ID # CBR-2123-4

Volvo Chassis - Model VNR With RH Side Fairing Only - Heat/Splash Shield Loose, Possible DTC P204800 And/Or P204713

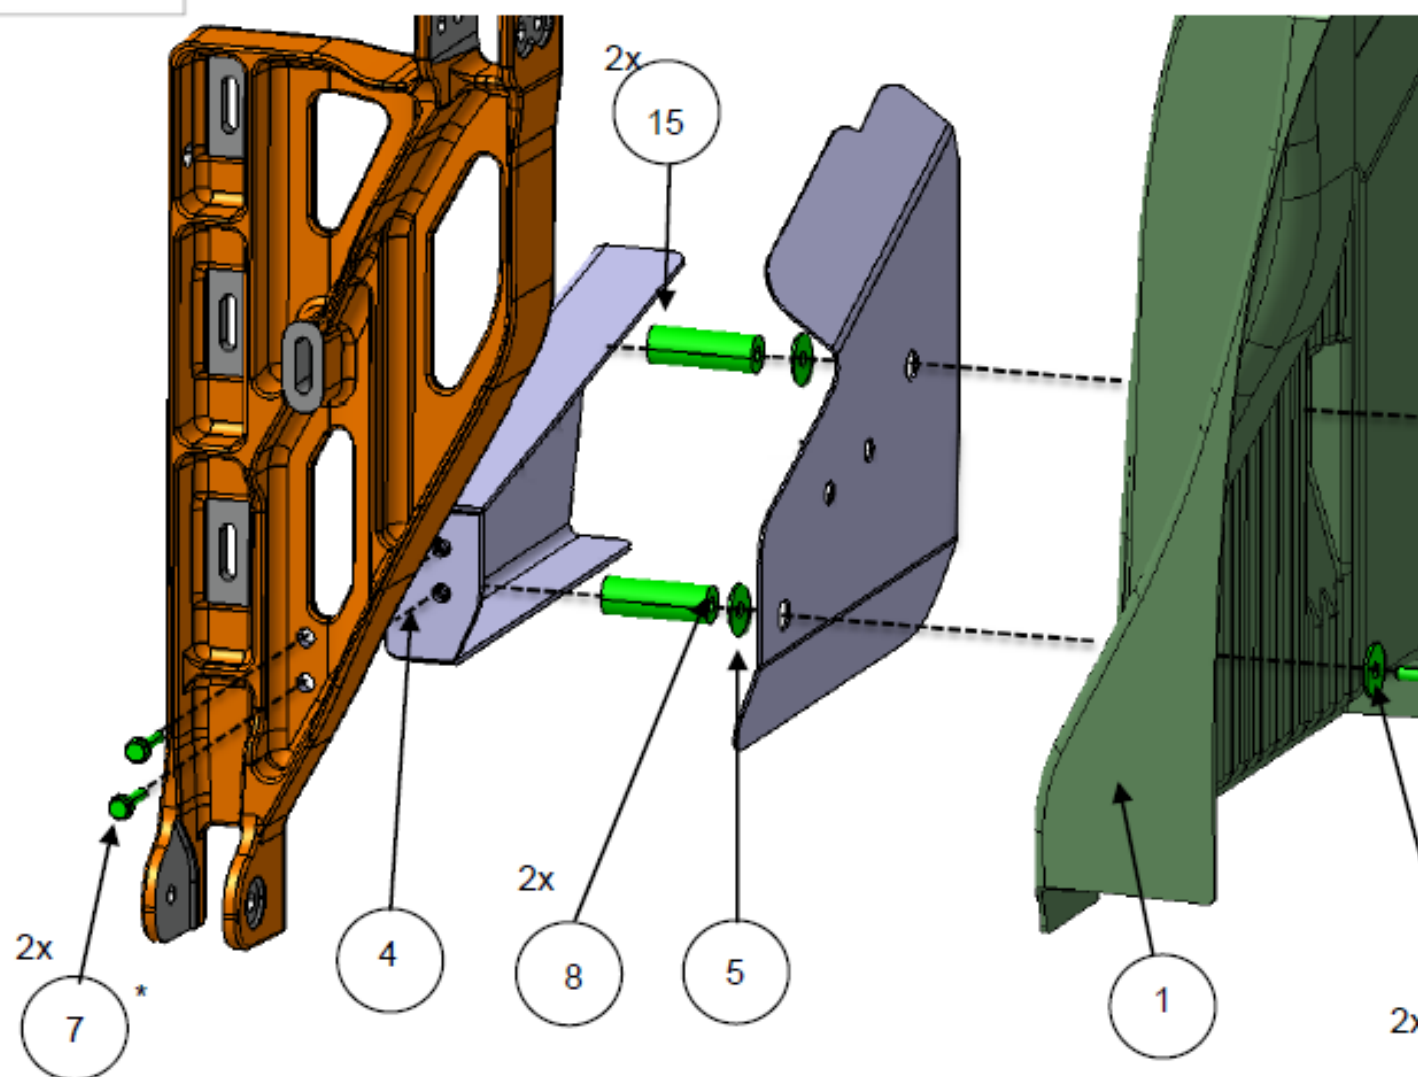
On certain Volvo VNR chassis equipped with a right-hand (passenger) side fairing, there is a possibility that the bolts securing the EATS heat shield/splash shield may become loose. This may lead the shield to rub on the EATS wiring harness, resulting in damage.

Diagnostic Trouble Codes (DTC) P204800 and P204713 may be observed as a result of the harness fatigue due to the loose shield.

1. Remove the 2 bolts (#14 in the image below) securing the heat shield.
2. Install split lock washer 20704747 below the bolt head.
3. Reinstall the bolts
 - The bolts should be torqued to 20 ± 2 Nm (14.75 ± 1.5 lbf)
